CITY PLAN COMMISSION STAFF REPORT

CD-CPC-2026-00064

11530 NW Prairie View Road Development Plan

Development Plan (non-residential)

True Parkings Covered Structures

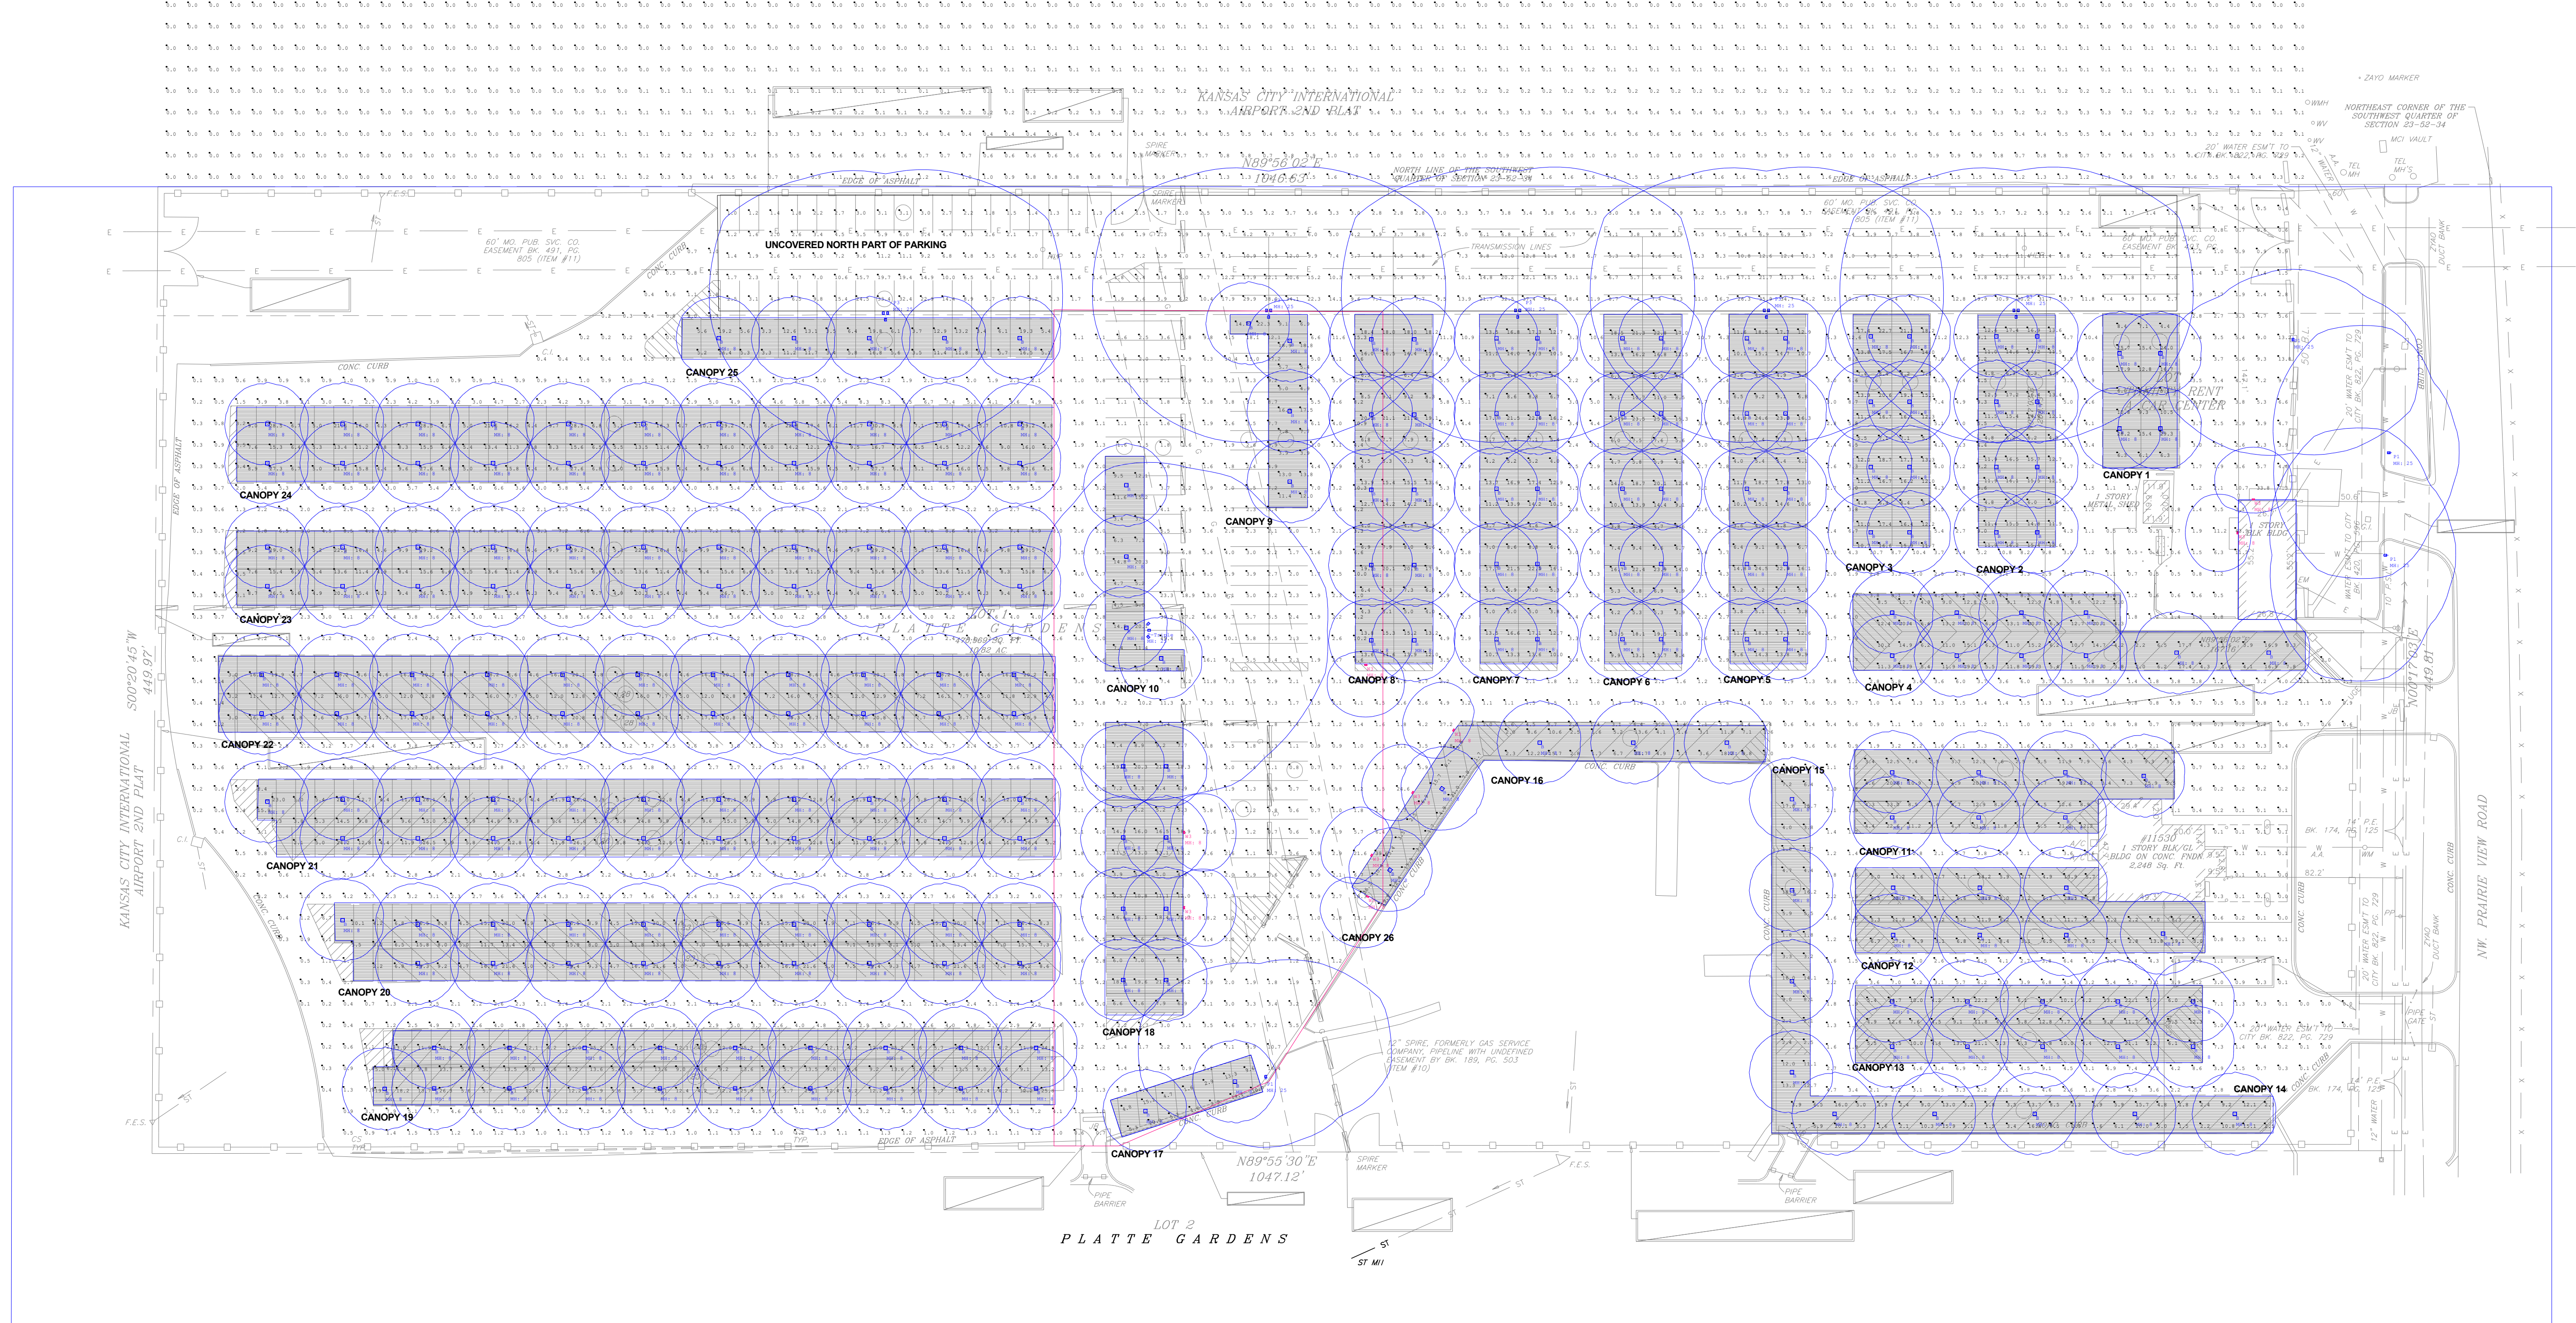
10. After discussion with property owner- prior to obtaining final plan approval, the lighting plan at a minimum shall show a lighting increase in the area between Canopy 8, 9, 10, 17, 18, 26 and near the east side vehicle entry/exit points where the lighting levels are 0fc-.10fc. Development Management Division reviewer may satisfy this condition.
